Reference: 220708.01FA

DESIGN ADVICE AND SWEEP PATH ANALYSIS FOR THE PROPOSED MONARO FIRE CONTROL CENTRE AT GEEBUNG STREET, POLO FLAT

Project
**NSW RURAL FIRE SERVICE -
MONARO FIRE CONTROL CENTRE**

Drawing Title
GROUND FLOOR PLAN - NORTH

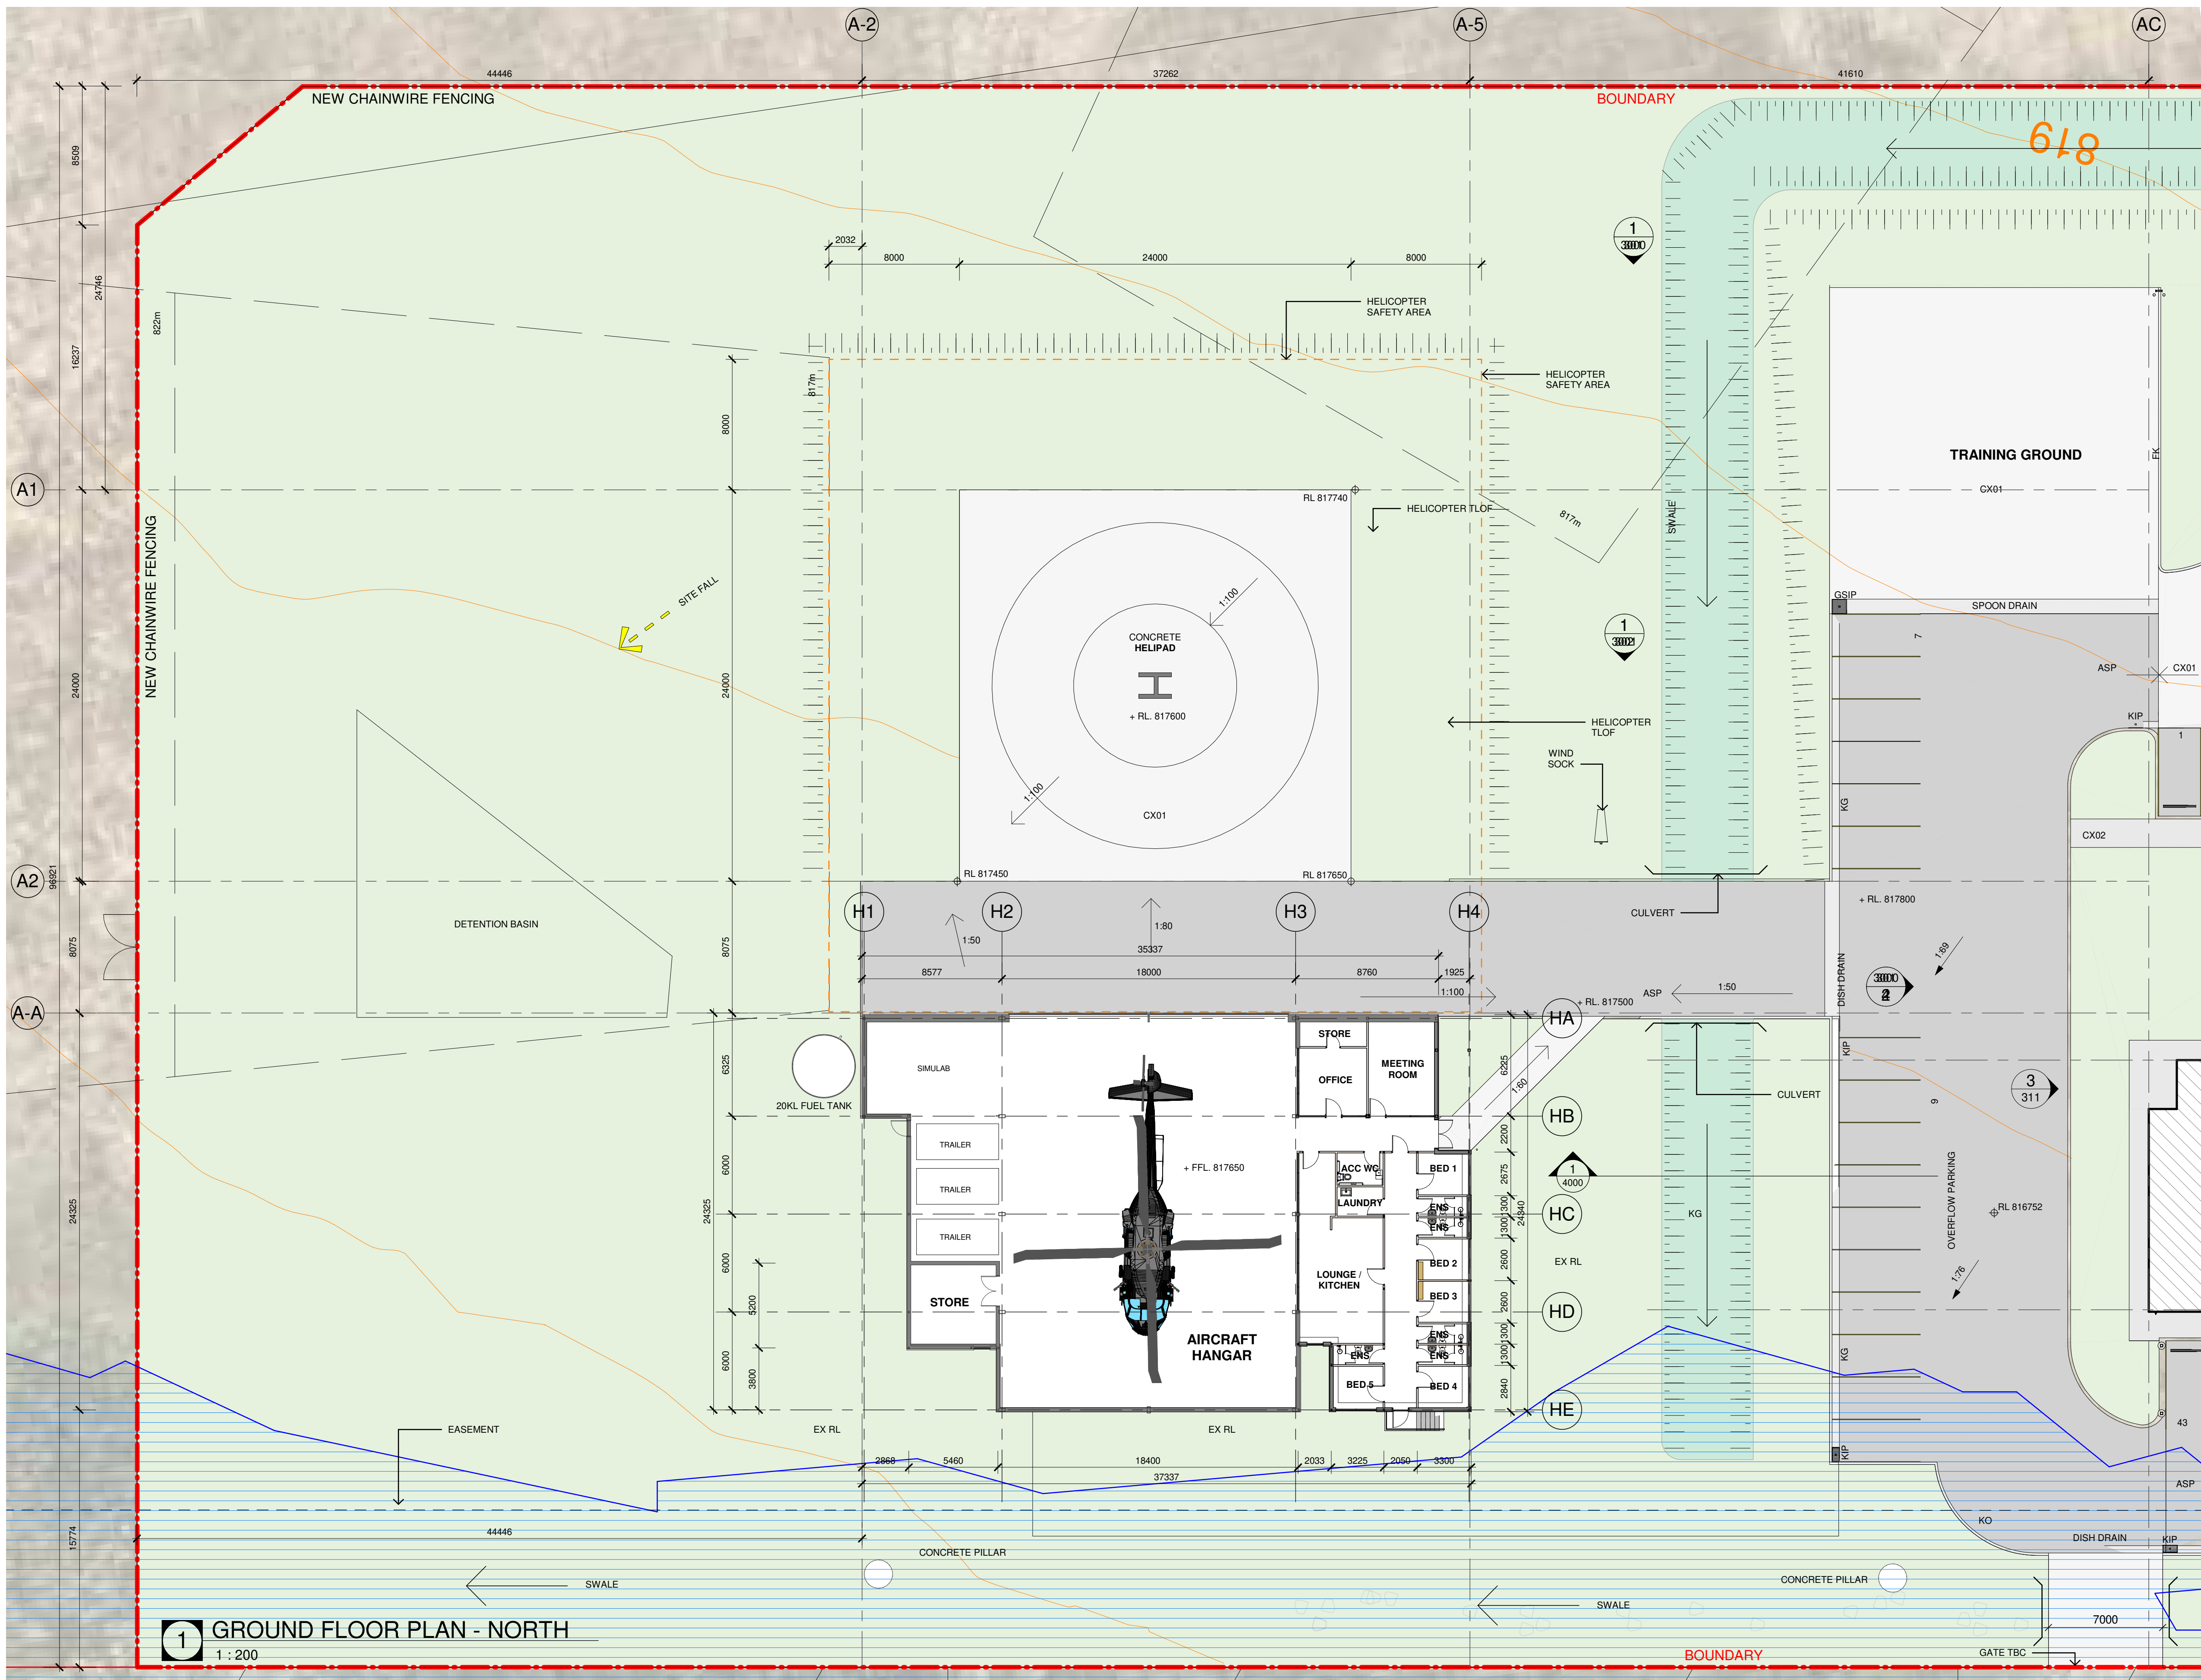
1.2.1 Bollards Underneath Downpipes / Roof Edge

The minimum headroom underneath the roof awning of the stores building is less than the minimum 4.5m required under *AS2890.2:2018* with further restrictions caused by downpipes resulting in headroom clearances lower than 4.0m. To prevent circulating AVs from potential collisions with the roof / downpipes and fire vehicles from colliding with the downpipes, bollards are required to be detailed underneath the downpipes at the edge of the roofline.

The swept path results indicate that AVs can circulate the site without encroaching underneath the roofline and fire vehicles can successfully enter and exit the District Vehicle Store bays in the instance where bollards are installed. This change can be made during detailed design at the Construction Certificate stage.

AV Fuel Tanker Entry / Exit from Hangar Bay
 2 Manoeuvres REVERSE IN / 1 Manoeuvre FORWARD OUT
Successful – Under a plan of management

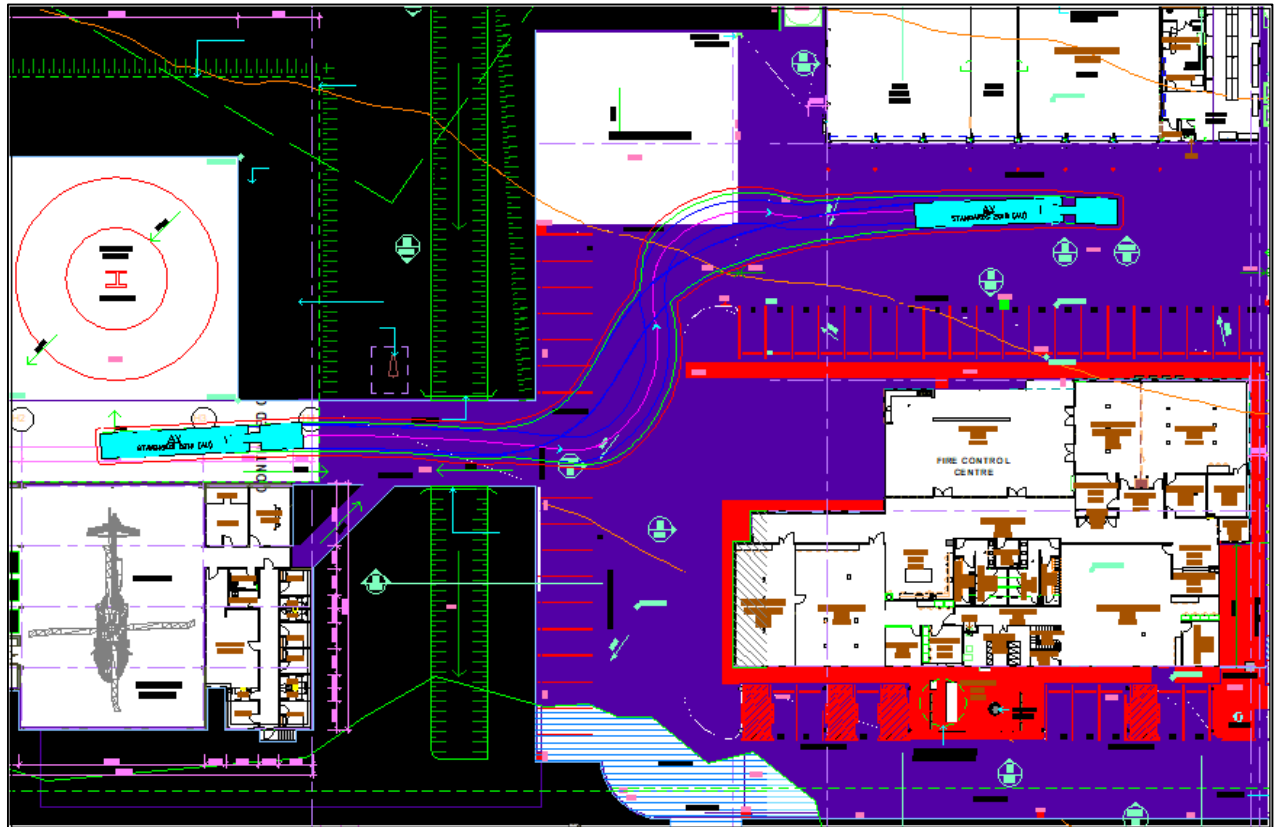
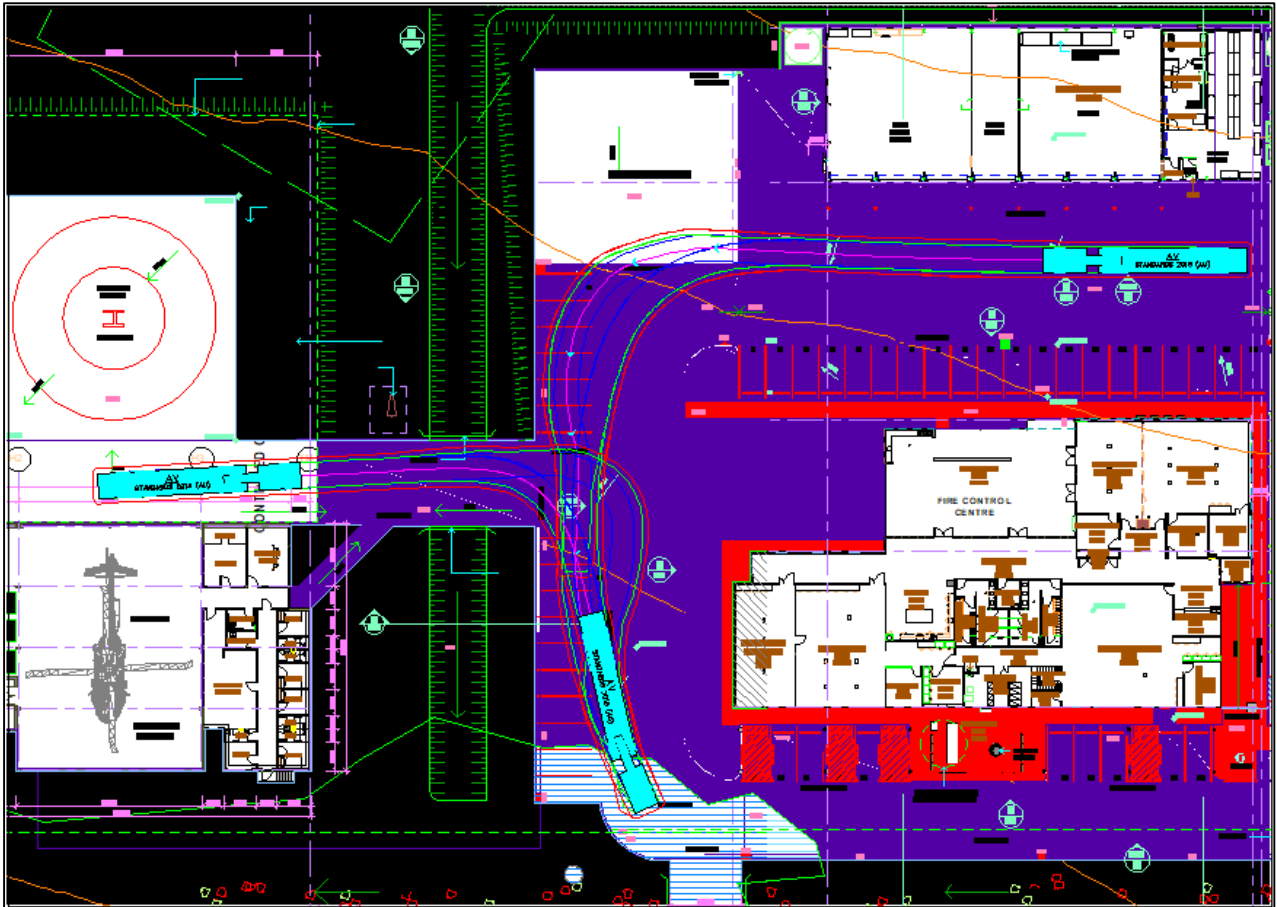
It should be noted that the swept path for the fuel tanker to access the aircraft hangar requires the overflow parking area and training ground for manoeuvring. The fuel tanker shall operate under a plan of management to ensure that there are no cars parked in the overflow parking area and that the training ground is clear of obstructions and activity when the fuel tanker is scheduled to undertake deliveries to the aircraft hangar. It has been advised that AVs will only use the eastern driveway of the site for access. Subject to the required changes in **Section 1.2**, the design vehicles are able to successfully access the proposed development.
